Project	IEEE 802.16 Broadband Wireless Access Working Group < http://ieee802.org/16 >	
Title	Handoff text clarifications and enhancements	
Date Submitted	2004-05-10	
Source(s)	Yigal Leiba Itzik Kitroser Yossi Segal Zion Hadad Runcom Technologies Ltd. 2 Hachoma St. 75655 Rishon Lezion, Israel	Voice: +972-3-9528440 Fax: +972-3-9528805 yigall@runcom.co.il itzikk@runcom.co.il yosis@runcom.co.il zionh@runcom.co.il
Re:	Contribution on comments to IEEE P802.16e/D2	
Abstract	Contribution elaborating on HO process optimization	
Purpose	To be integrated into IEEE P802.16e/D2 document	
Notice	<p>This document has been prepared to assist IEEE 802.16. It is offered as a basis for discussion and is not binding on the contributing individual(s) or organization(s). The material in this document is subject to change in form and content after further study. The contributor(s) reserve(s) the right to add, amend or withdraw material contained herein.</p>

HO text clarifications and enhancements

Figure 1: HO process

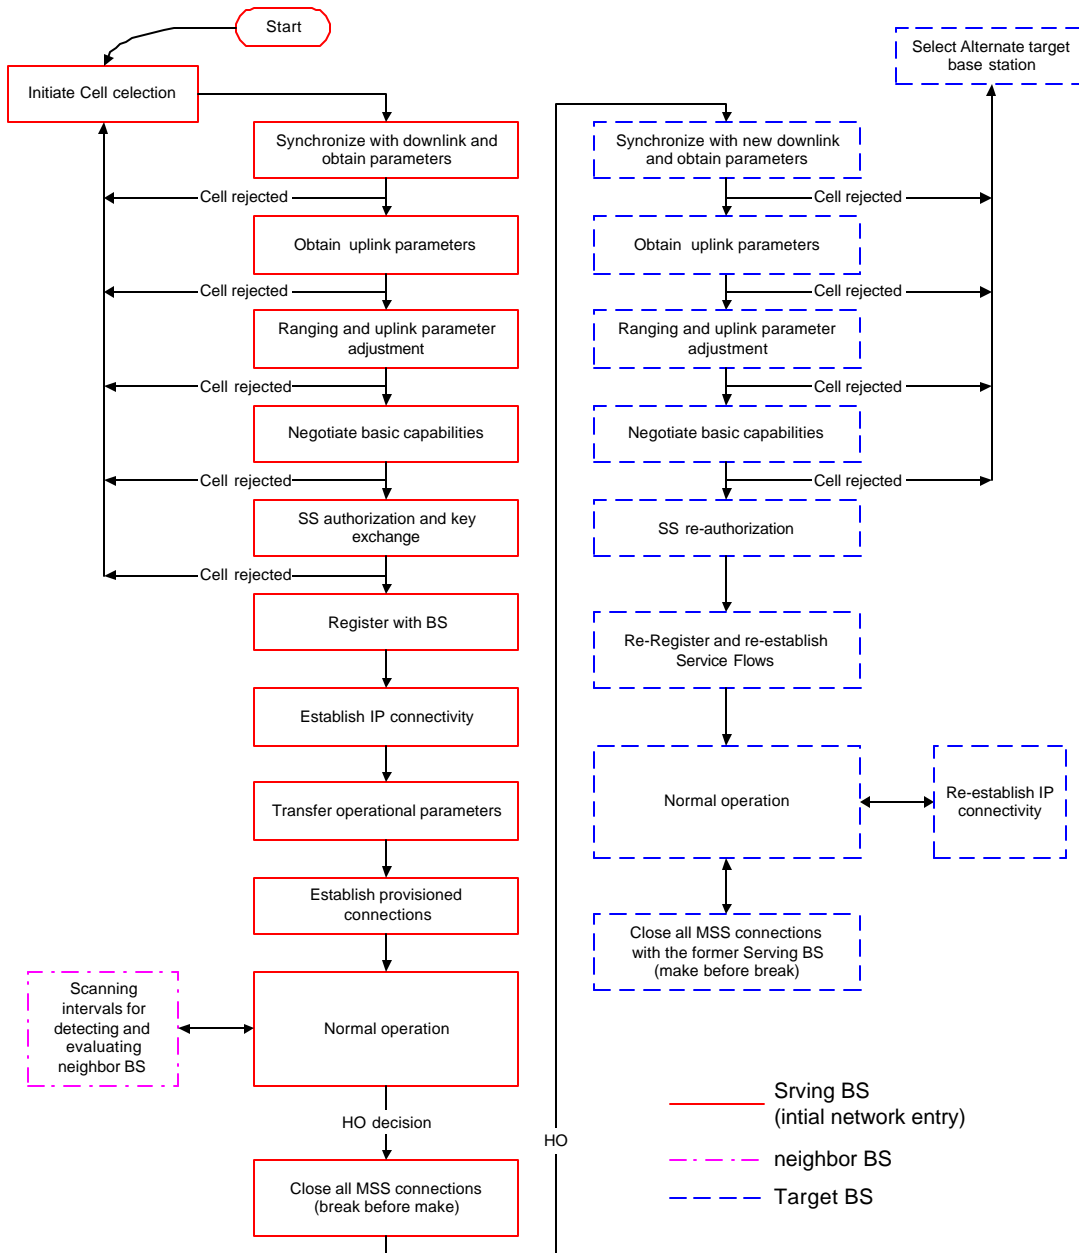
Figure 1 below depicts the current initial network entry and HO process. Several message exchanges having to do with HO can be streamlined or postponed in order to speed-up the HO process.

1. RNG-REQ/RSP exchange – A Non-contention RNG-REQ/RSP (otherwise known as ‘invited ranging’) should be by the target BS. This should be possible by using the timing estimation fields in the HO messages. One RNG-REQ/RSP exchange should suffice, because the SS has most of the information required to send the RNG-REQ message with nearly correct parameters (i.e. timing and power).

2. SBC-REQ/RSP exchange – This exchange can be postponed until after the MSS completes the HO process and settles back in Normal mode. In the meanwhile the BS and MSS will only communicate using mandatory features of the standard.

3. PKM-REQ/RSP exchange – This exchange could be skipped if we do pre-authentication before HO, via the backbone. In such case, the MSS and the target BS will share a secret, that can be used after HO to derive a TEK, such that PKM can continue its operation seamlessly.

4. BW allocation for the MSS for message exchanges – It may be worthwhile to add text describing what is expected of the BS during the HO process in terms of allocating UL BW for the MSS for speedy HO.
